# AMENDENT NO. 1 FOR THE SUPPLY, INSTALLATION, TESTING, COMMISSIONING & MAINTENANCE OF ON GRID (SOLAR PHOTO VOLTAIC) POWER PLANT, OFF GRID (SOLAR PHOTO VOLTAIC) POWERPLANT AND SOLAR WATER HEATER AT CANARA BANK, CENTRE OF EXCELLENCE, GURUGRAM

### CAR PARKING STRUCTURE (TENTATIVE)

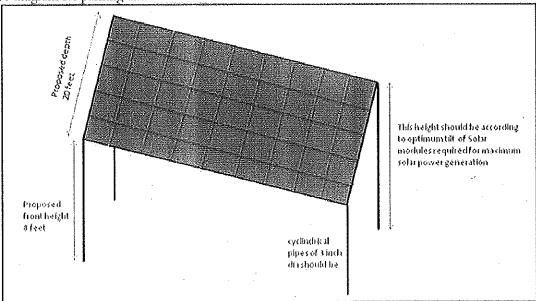
The height of Solar PV Car parking shed at front is proposed to be minimum 8 feet and should be raised to suitable height at back for optimum tilt angle. The spacing between modules shall have to be designed in such a way that there is no leakage of water from solar PV panels and Solar PV panels should act as leak proof roof for parking. Suitable material and design modification should be used for such purpose

Tentative diagram for parking dimensions is shown below:

The above dimension are tentative and may change as per design consideration at the time of installation. The availability of suitable ground area is approximately 400 Sqm.

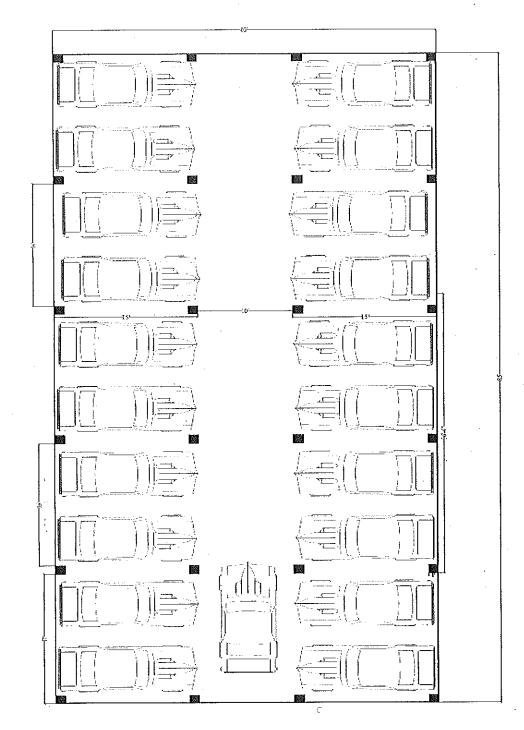
PCC ARRAY FOUNDATION BASE: The legs of the structures made with GI angles will be fixed and grouted in the PCC foundation columns made with 1:2:4 cement concrete. The minimum clearance of the lowest part of any module structure shall not be less than 500 mm from ground level. While making foundation design, due consideration shall be given to weight of module assembly, maximum wind speed of 150 km/hr and seismic factors for the site.
